# REQUEST FOR BOARD ACTION

## HENDERSON COUNTY PLANNING BOARD

**SUBJECT:** Master Plan for The Farm at Eagles Nest (Hammond Tract) (#2017-M08)

**Henderson County Planning Department Staff Report**

PHASING PLAN

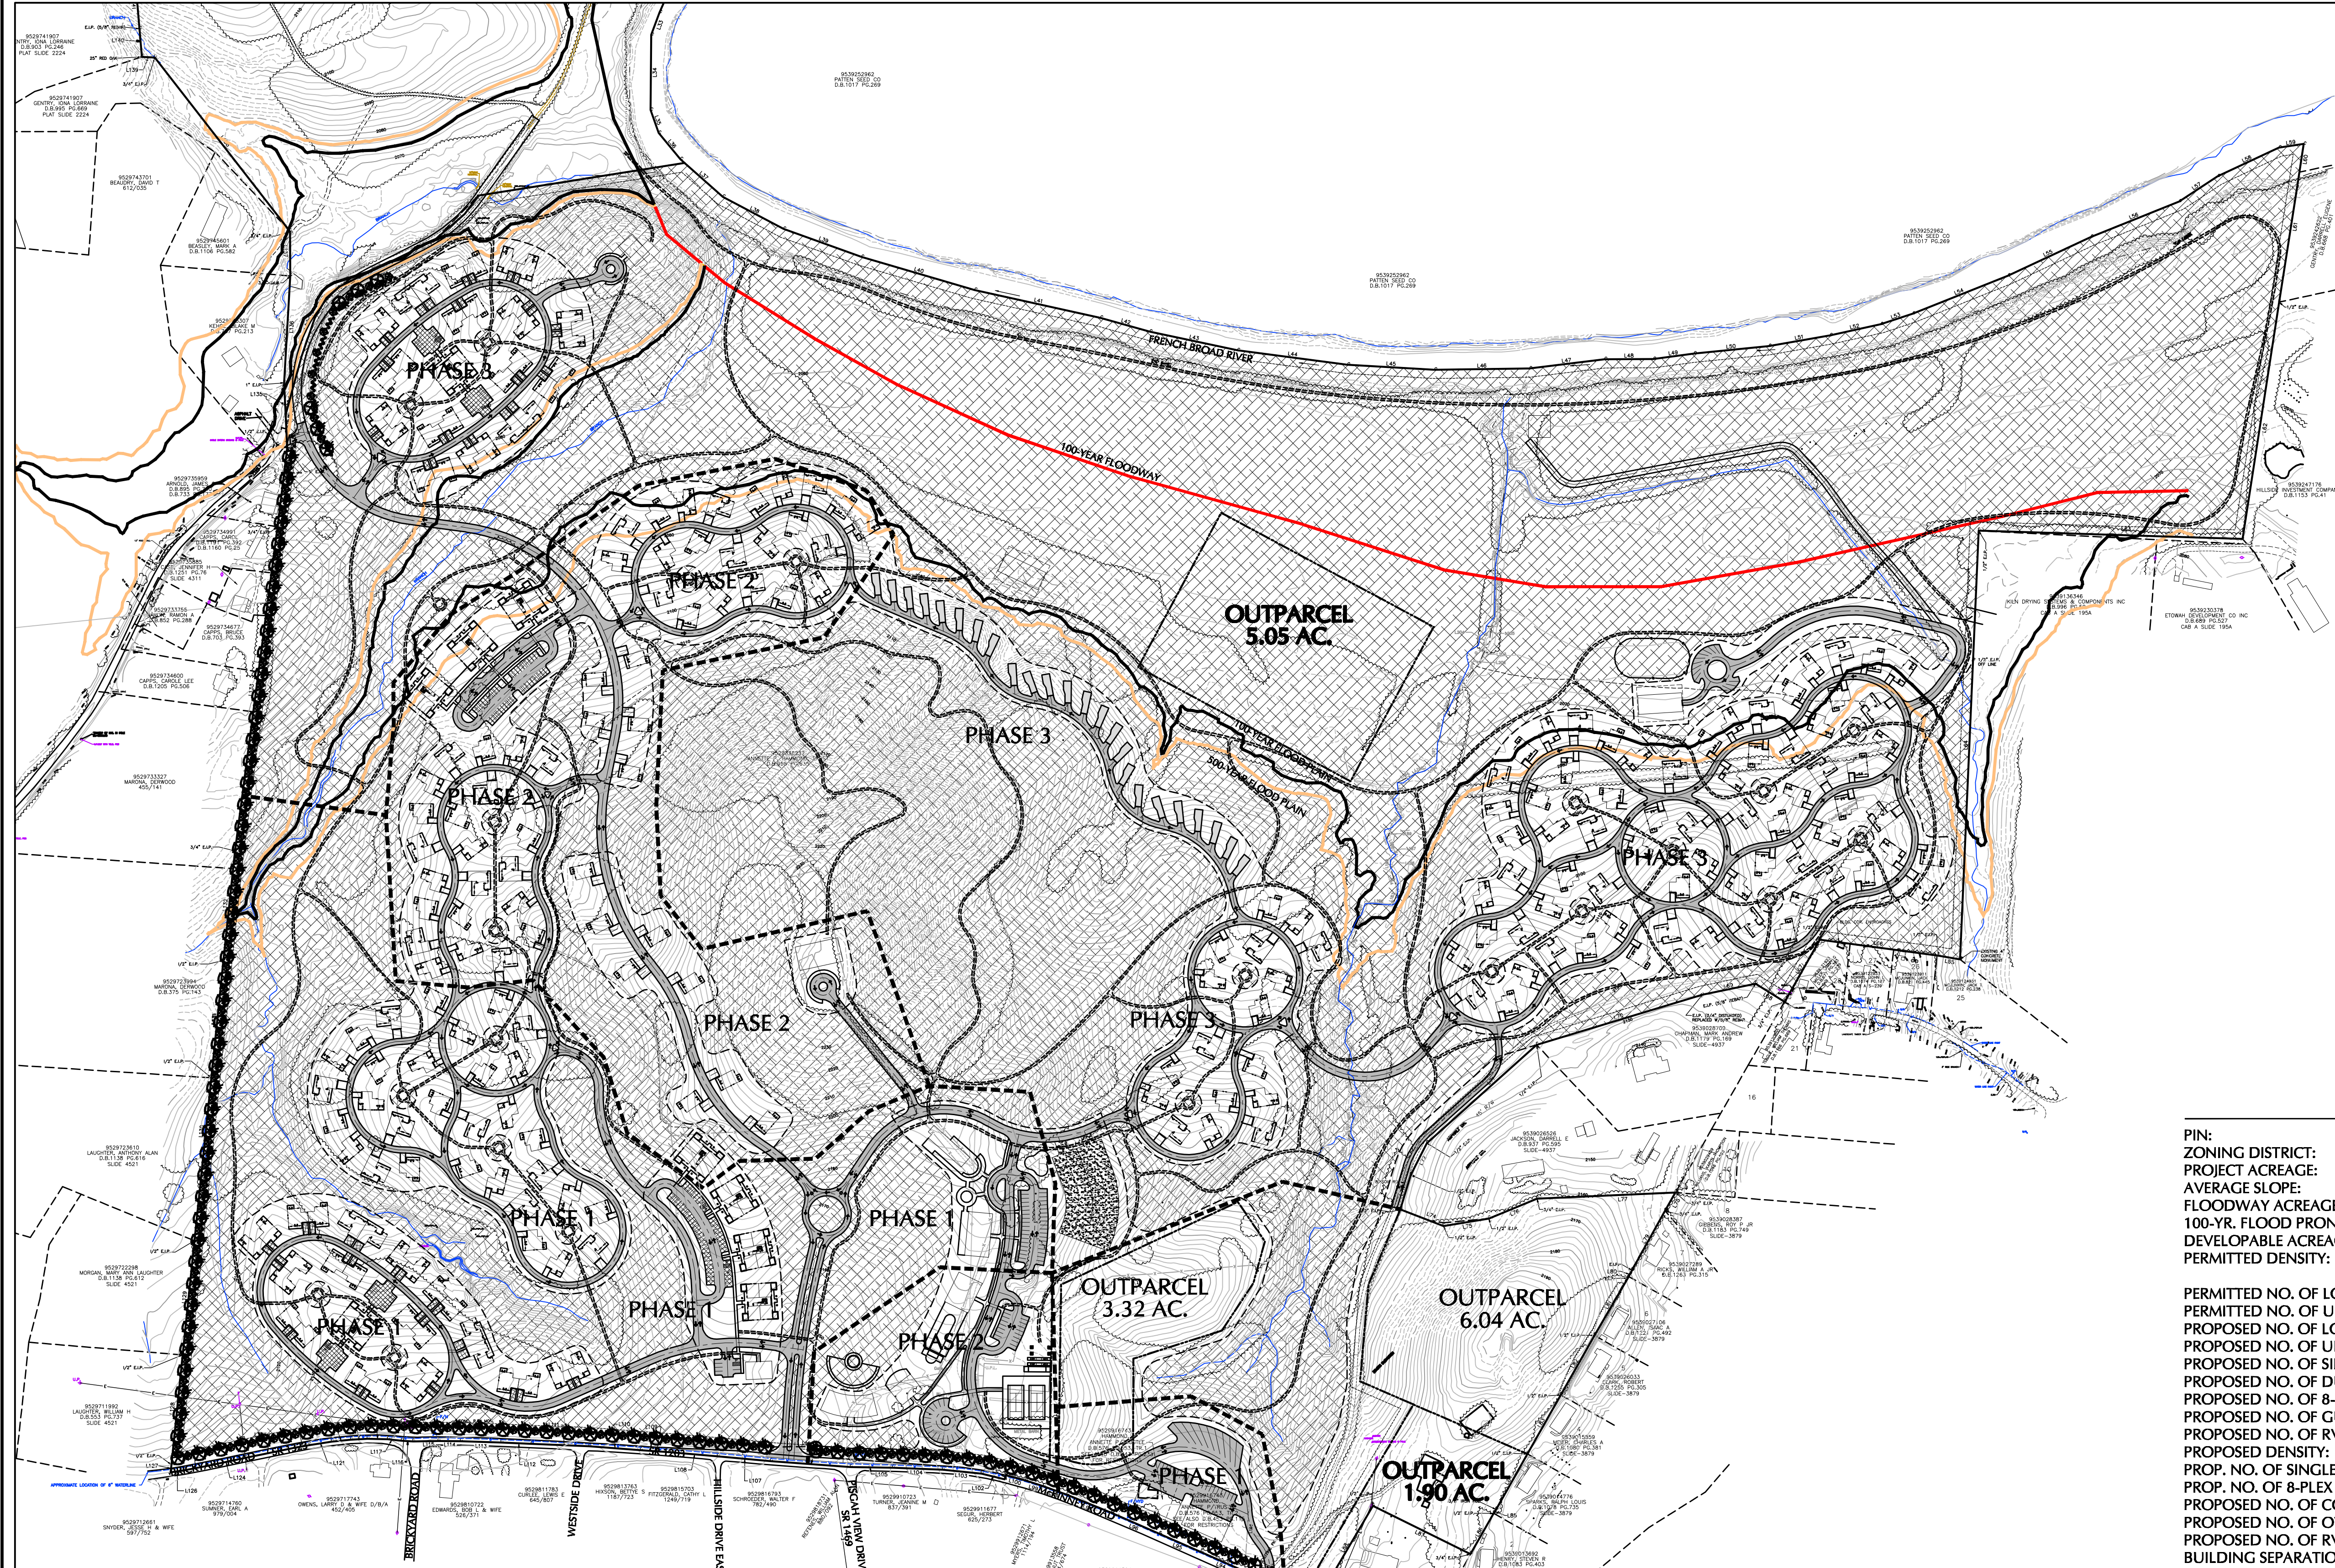
- 299 Dwelling Units
  - 169 Single Family Units
  - 58 Duplex Units (30 structures)
  - 72 8-Plex Units (9 structures)
  - 1 Guest Suite
- 24 RV Spaces
- 138.59 Acres of Open Space (64.2%)
- 32.62 Impervious Surface Acreage
- 29,866 Linear Feet of Roads
- 4 Outparcels
- Proposed Density: 1.38 Units/Ac.
- Amenities: Restaurant, Clubhouse, Art Center, Wellness Center, Motorcycle/Car Display Building, Barn with guest suite, Pavilion, Ridding Ring, Art Studio, Art Gallery, Pool, etc.
- Additional Buildings: Administration Building, Maintenance, Storage Building

1. **Purpose of the Master Plan.** The master plan is intended to provide general information about the proposed development to allow for an assessment of its impact on the orderly growth and development of the County, environmental quality, land values, natural features identified on the site analysis sketch and the County's *roads* and governmental services. Improvement are required at the development plan approval.

3. **Private Road Standards.** The Applicant has indicated private road construction throughout the three different phases. All subdivision roads must be designed and constructed to the minimum standards of LDC §42A-81 C (Table 3.1)

6. **Pedestrian Access.** Sidewalks or walking trails are required for any major subdivision of 35 or more lots outlined in Henderson County Code Chapter 42 (LDC §42-113). Reasonable pedestrian access shall be provided to promote healthy and safe walking when a developer proposes a density equal to or greater than two (2) units per acre. The applicant must provide one (1) linear foot of sidewalk or
